21 August 2018

NOTICE OF APPROVAL OF AMENDMENTS TO THE APRIL 2018 DELAY ATTRIBUTION PRINCIPLES AND RULES

Amend F1.6.1 Flowchart follows

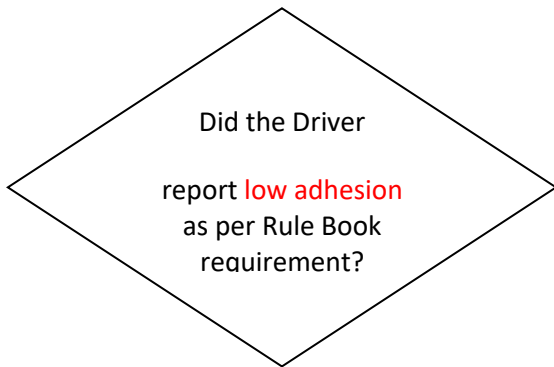
Replace the wording 'ERHC/LRA' with the words 'low adhesion' in the two diamonds that contain 'ERHC/LRA' so they read:-
